VIRGINIA ELECTRIC AND POWER COMPANY
RICHMOND, VIRGINIA 23261

VIRGINIA ELECTRIC AND POWER COMPANY
SURRY POWER STATION UNITS 1 AND 2
RESPONSE TO REQUEST FOR ADDITIONAL INFORMATION
ALTERNATE SOURCE TERM - PROPOSED TECHNICAL SPECIFICATION CHANGE

**Supplemental Information Discussed in 11/21/01 Teleconference Between
Dominion and NRC Staff**

Surry Power Station Units 1 and 2

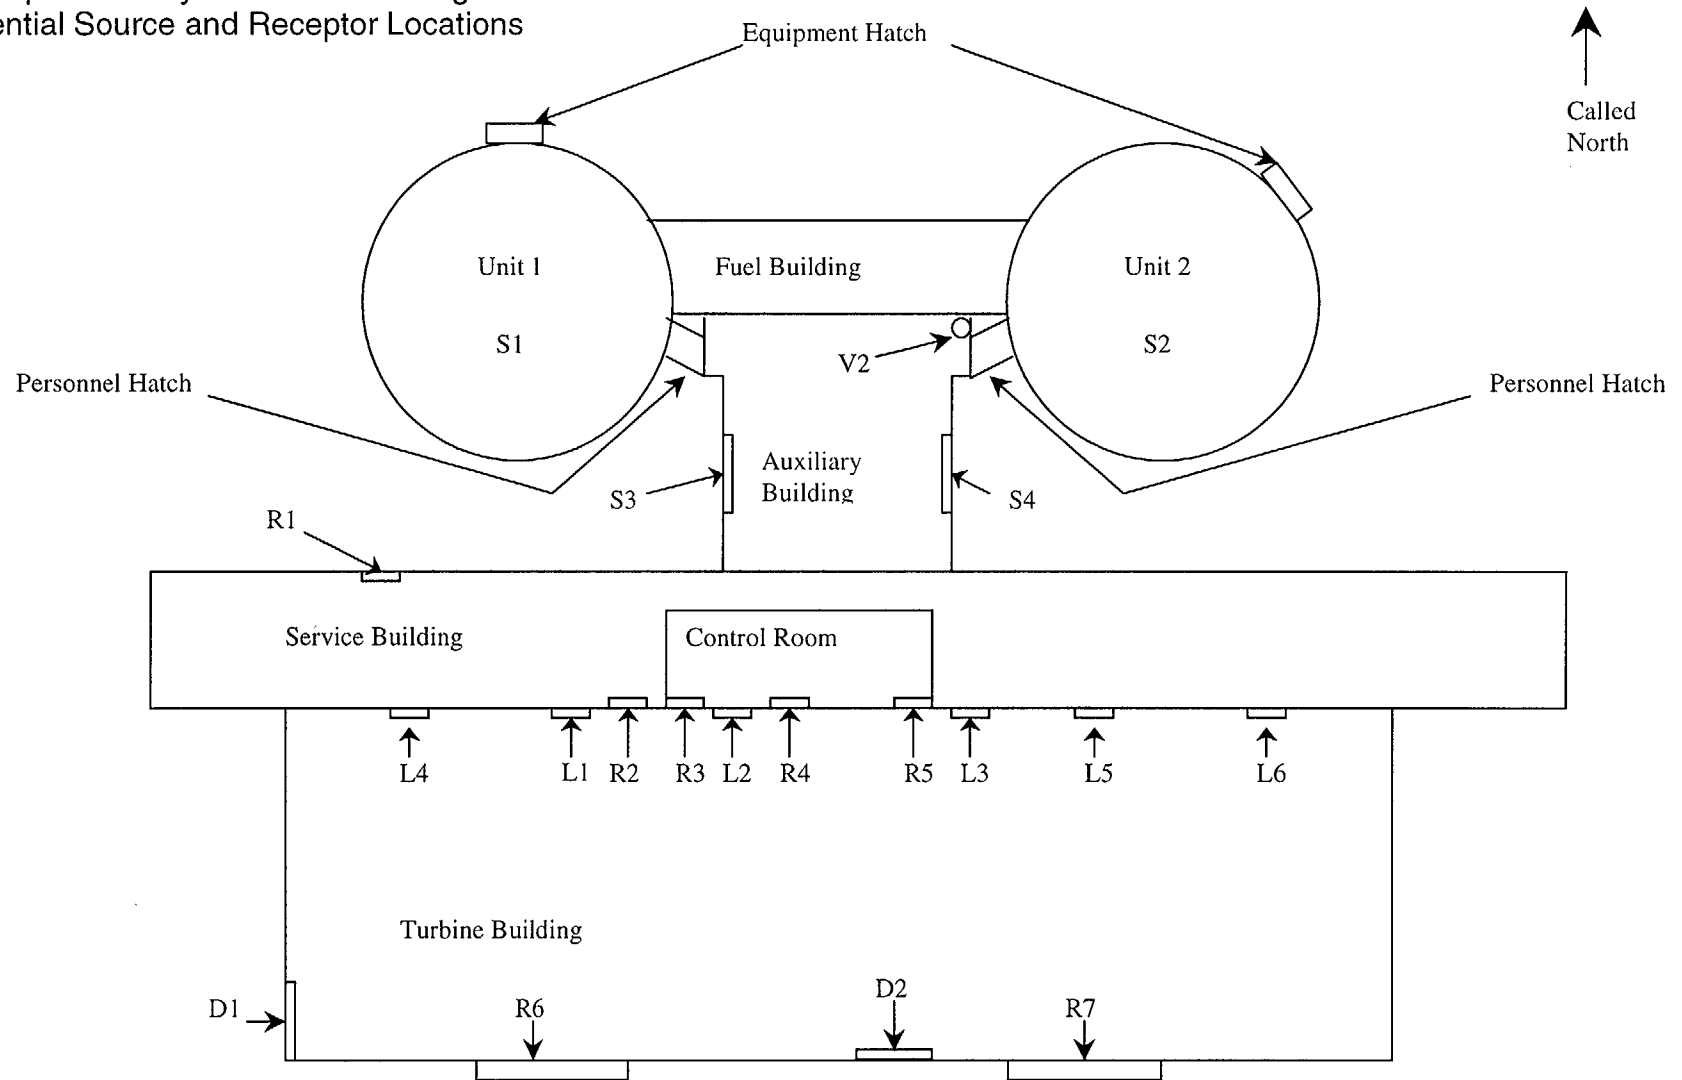
Please define what the key parameter values are and specifically whether any reanalysis of the core inventory with ORIGEN2 is anticipated for reload cores.

Section 3.2.2.4 of the revised AST Analysis Report describes the time-average linear heat generation rate (LHGR) as the key fuel rod parameter affecting fission gas release for use in the Fuel Handling Accident analysis. The specific key parameter modeled is the time-average LHGR after 3 cycles of irradiation, calculated assuming assembly average rod powers. The stated commitment involves confirming that the cycle-specific LHGR values, defined in the above fashion, will result in fission gas gap fractions less than or equal to the following values used in the FHA analysis:

Once-Burned Gap Fraction = 3.0%
Twice-Burned Gap Fraction = 5.35%
Thrice-Burned Gap Fraction = 6.0%

Since various combinations of assembly rod power and burnup history can satisfy this condition, the constraint is specified in terms of LHGR and associated fission gas gap fractions. Dominion will confirm, during the course of performing reload design calculations for the Surry cores, that all fuel assembly locations satisfy this requirement. Reanalysis of the core inventory with ORIGEN2 is **not** anticipated for reload cores.
